SERVICE BULLETIN

M1384

2015 HARLEY-DAVIDSON STREET FUEL TANK - SAFETY RECALL 0161

Figure 1. Fuel Tank

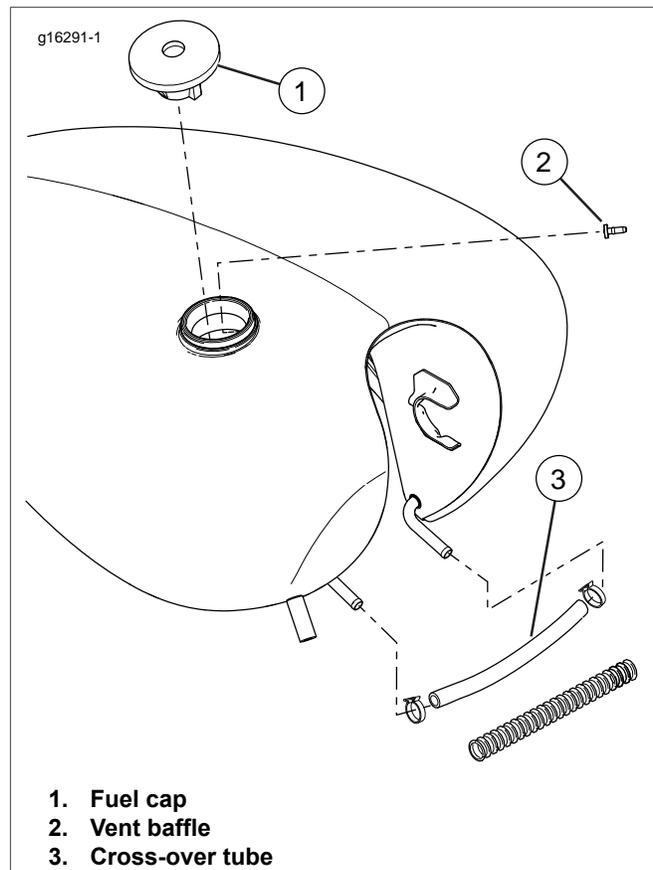
See Figure 1. New fuel tank will come with all components except:

- Vent baffle (2).
- Cross-over tube (3).
- Fuel cap (1).

When removing or installing vent baffle, cover fuel tank inlet to prevent vent baffle from falling into fuel tank.

2. Transfer vent baffle (2) from old tank to new tank.
3. Install new fuel tank. See service manual.
4. Install cross-over tube (3) and **new** clamps.
5. Fill fuel tank with fuel.
6. Install fuel cap (1) from old fuel tank to new fuel tank.

The fuel cap, once installed, must sit undisturbed for a minimum of 12 hours. This allows the cap seal to take the shape of the new tank.
